Roads & Amenity, Operational Services
Helensburgh / Lomond Area
Blairvadach House, Shandon.

OBSERVATIONS ON PLANNING APPLICATION

Proposed Development: Partial change of use of outbuilding to holiday let accommodation (retrospective)

Location: Tighairn Cottage, Arrochar, Argyll & Bute

Drawing No SD 08/002

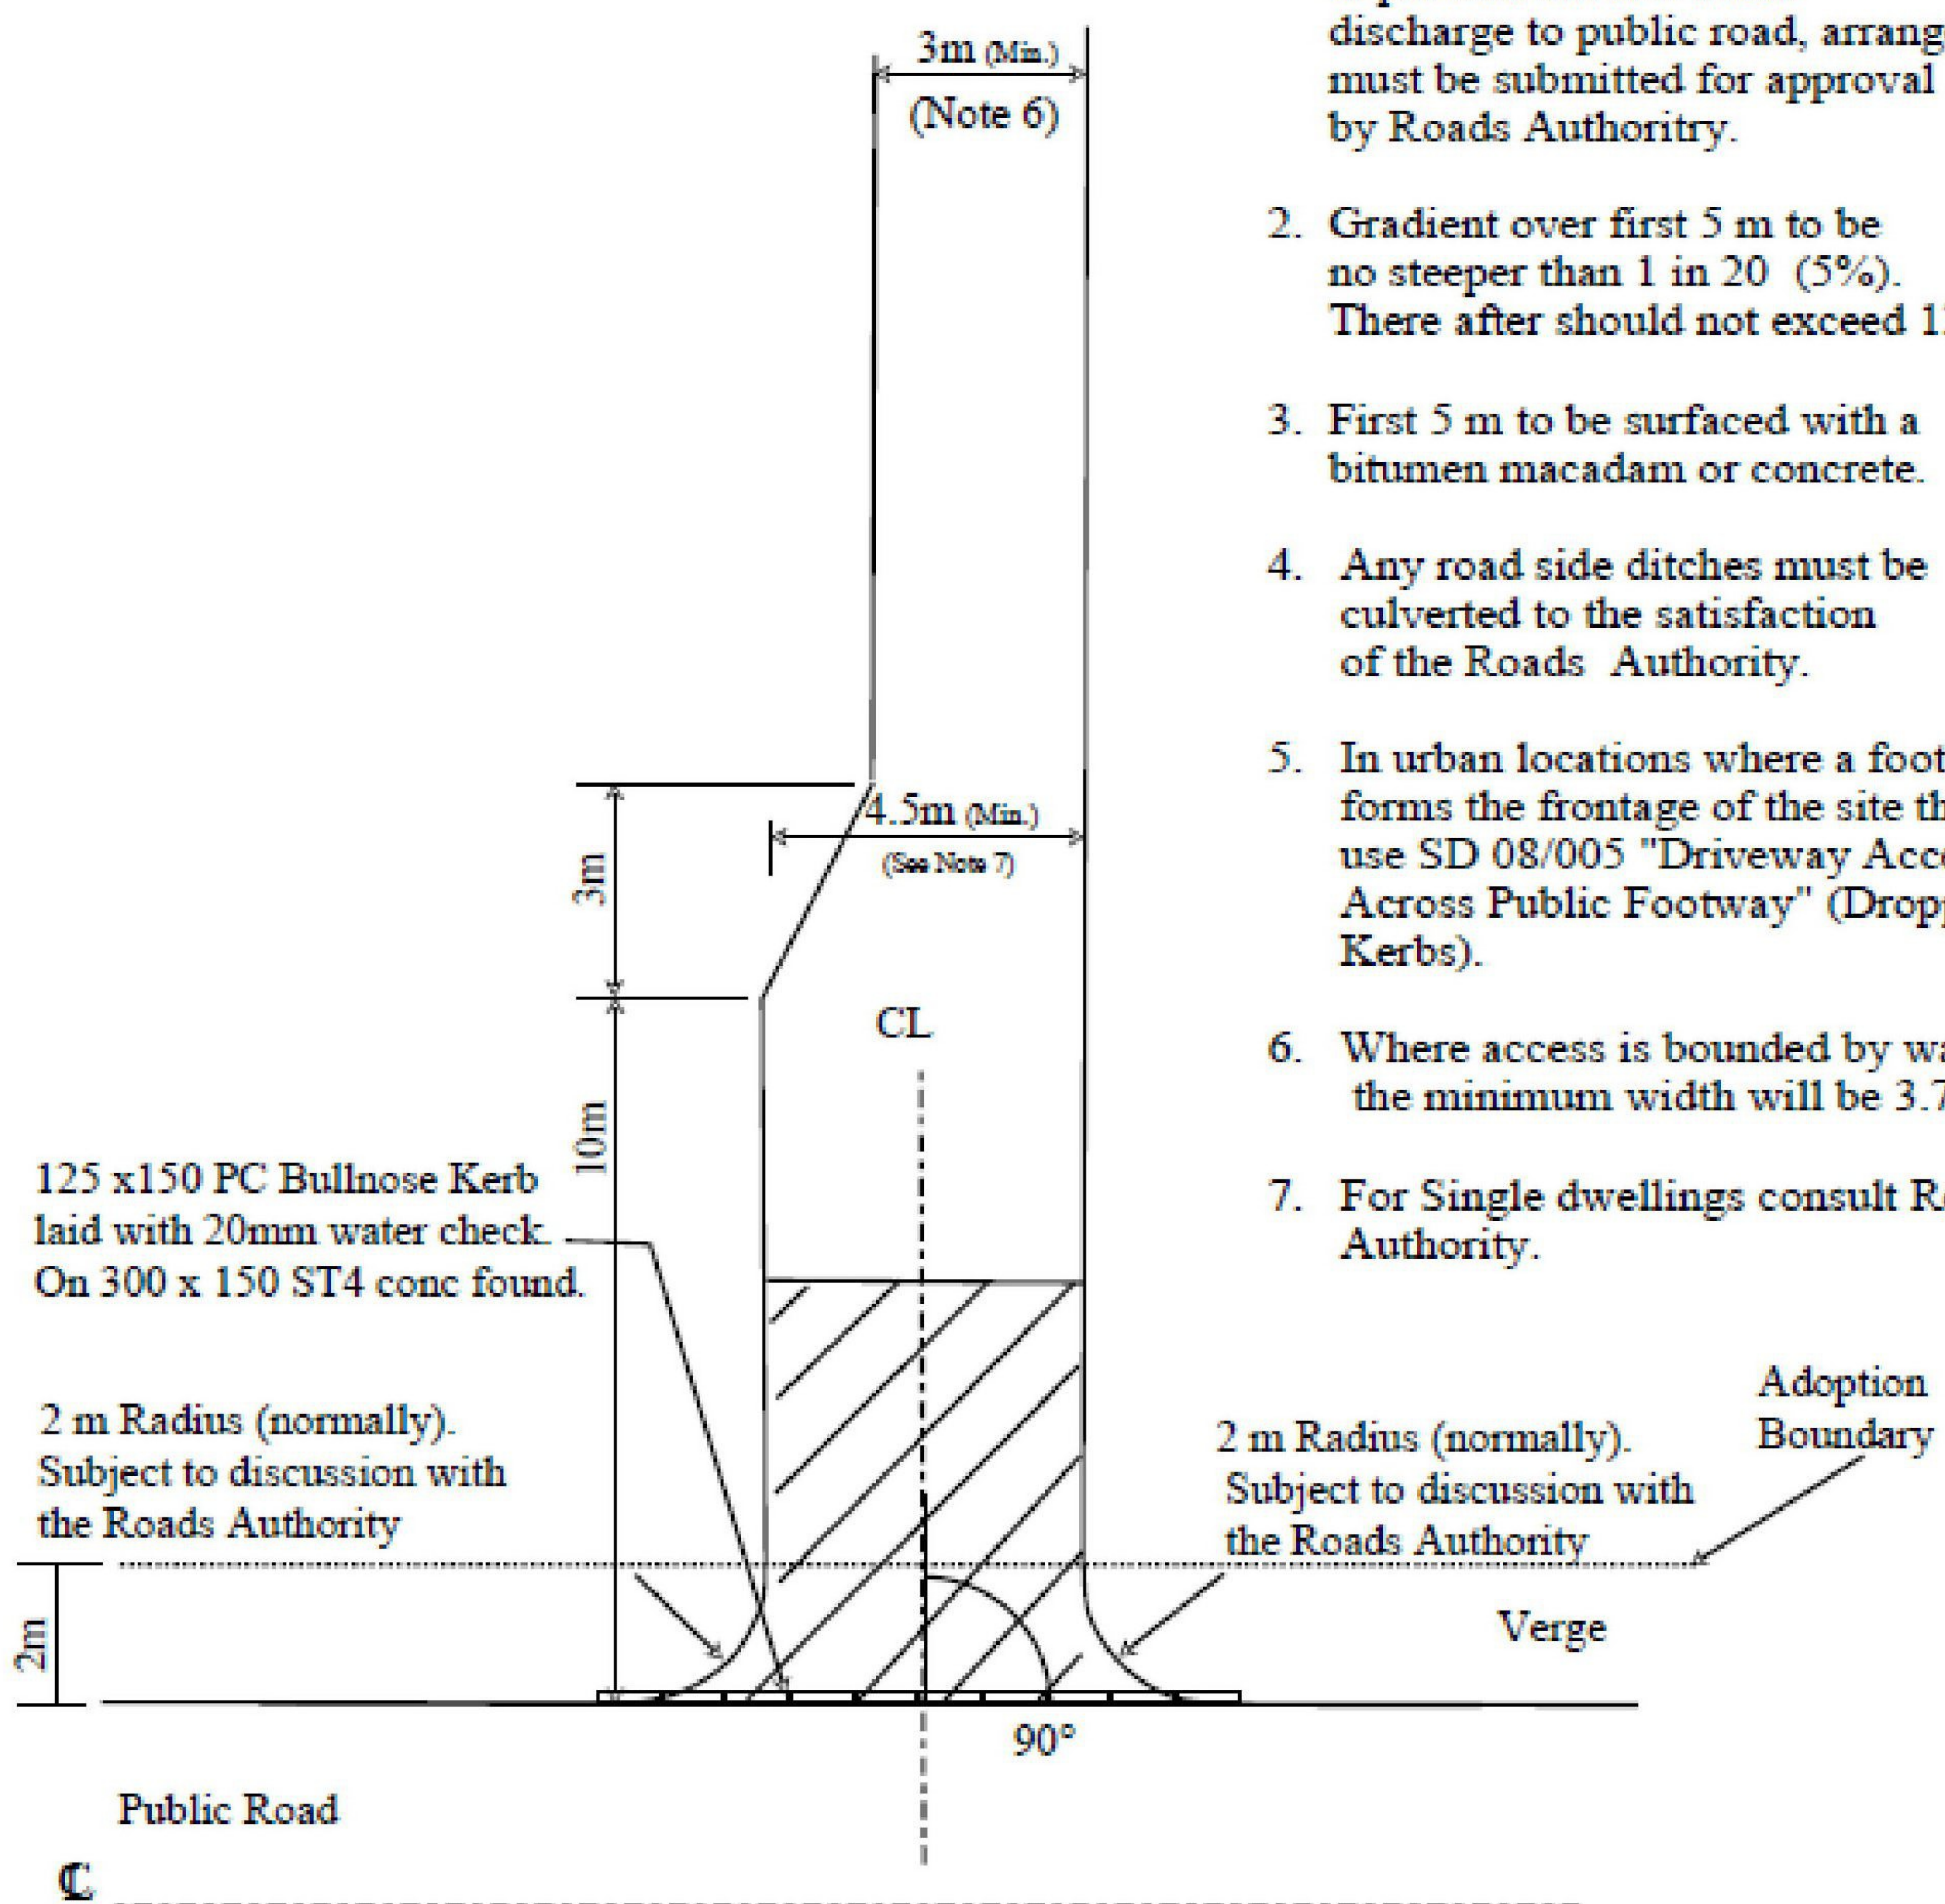
Item Ref.	COMMENTS
1	The proposal is situated off the A814 Arrochar – Dumbarton Road within a rural 60mph speed restriction.
2	Existing access is unsafe due to lack of visibility when exiting the property.

Item Ref.	CONDITIONS/REASONS FOR REFUSAL/DEFERMENT
2	There is no visibility in either direction when exiting the site due the 6ft tall timber fence along the roadside. This refusal could be changed to “No objections subject to conditions” if the following conditions can be met.
2c	Visibility splays of 120 x 2.4 x 1.05m required. No walls, fences, hedges etc permitted within the visibility splays. No obstructions to visibility over 1.05m in height permitted within the visibility splays
4d	Access to be constructed as per Drg No SD 08/002a.Min width 4.5m and surfaced in bitumen or concrete for the first 5m from the edge of the public road. (Road opening permit required)

1. Access to be formed or drained to prevent surface water discharge to public road, arrangement must be submitted for approval by Roads Authority.
2. Gradient over first 5 m to be no steeper than 1 in 20 (5%). There after should not exceed 12.5%.
3. First 5 m to be surfaced with a bitumen macadam or concrete.
4. Any road side ditches must be culverted to the satisfaction of the Roads Authority.
5. In urban locations where a footway forms the frontage of the site then use SD 08/005 "Driveway Access Across Public Footway" (Dropped Kerbs).
6. Where access is bounded by walls the minimum width will be 3.7m.
7. For Single dwellings consult Roads Authority.
